## COMMONWEALTH of VIRGINIA

### DEPARTMENT OF ENVIRONMENTAL QUALITY

April 18, 2013

**Re: Class 2 Permit Modification Request, dated February 8, 2013 – DEQ Approval  
Hazardous Waste Management Permit, Open Burn Area  
National Aeronautics and Space Administration (NASA)  
Goddard Space Flight Center (GSFC), Wallops Flight Facility (WFF)  
Wallops Island, Virginia  
EPA ID No. VA7800020888**

FIGURE D-2  
OB-AREA  
SUB-UNIT  
AS-BUILT DRAWINGS

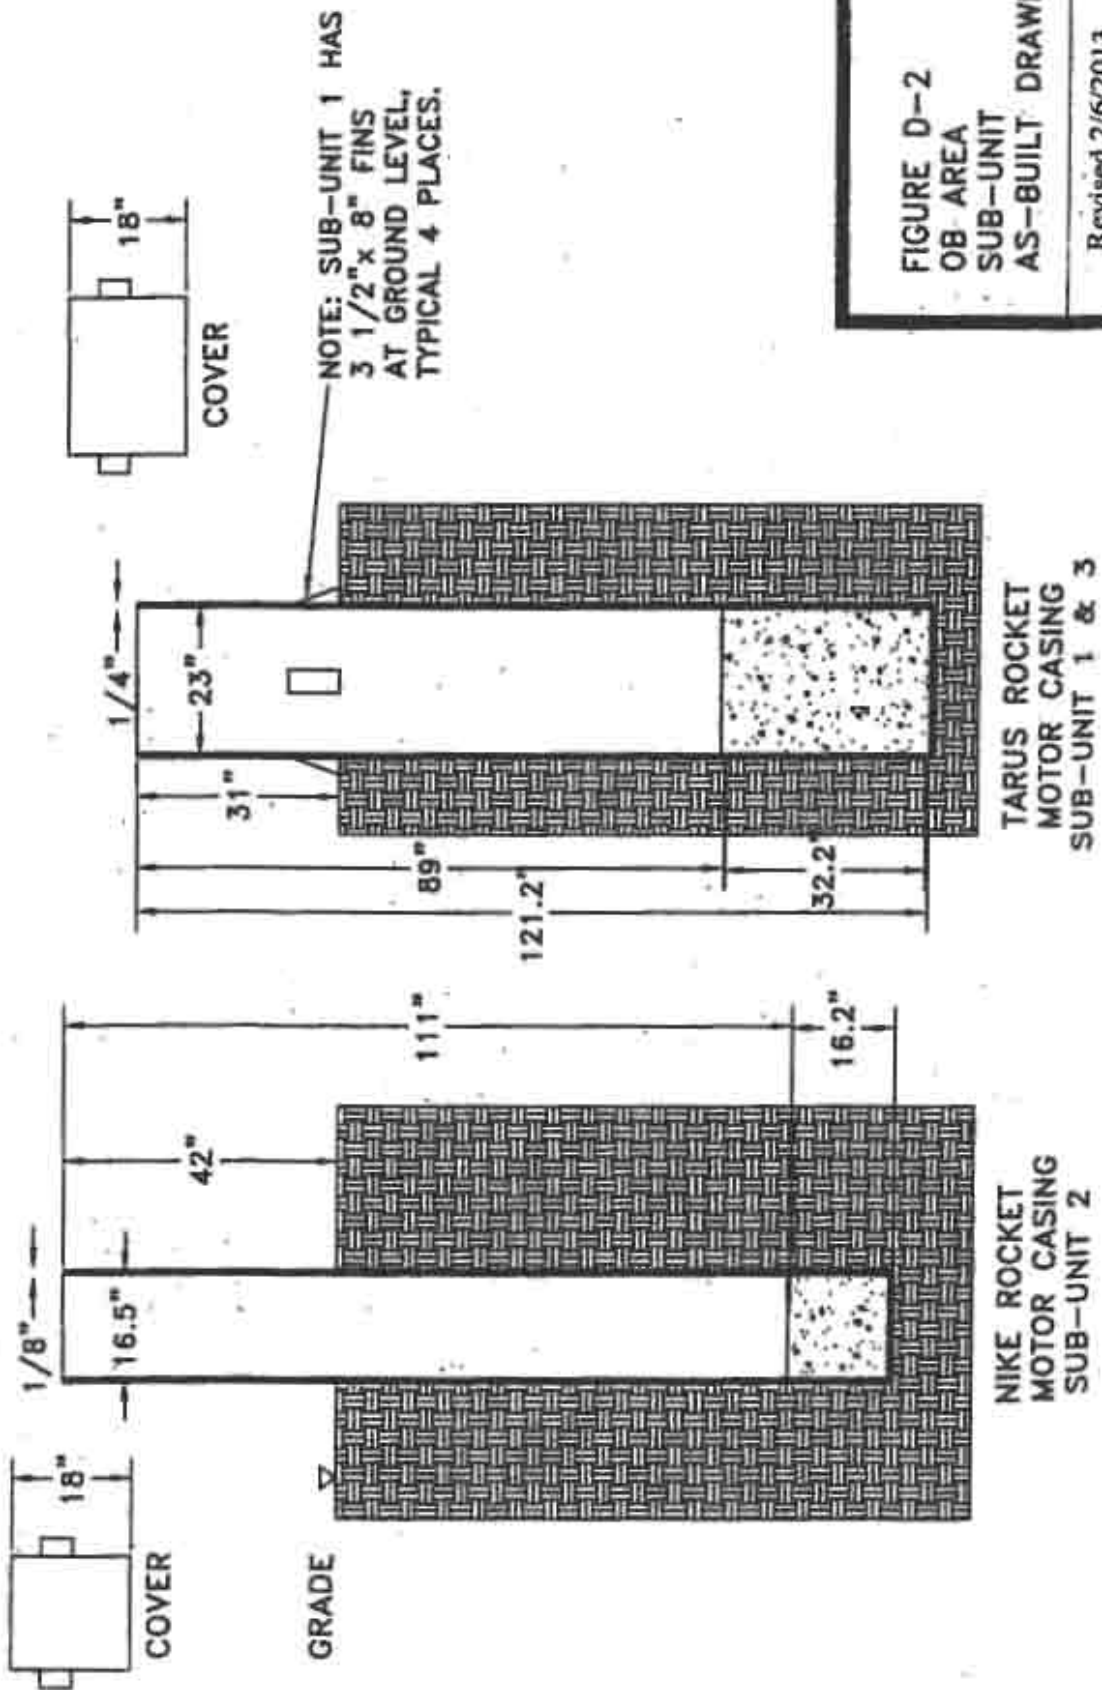
16. Module II, Attachment II.HH, Figure II-HH-2d – Figure revised.
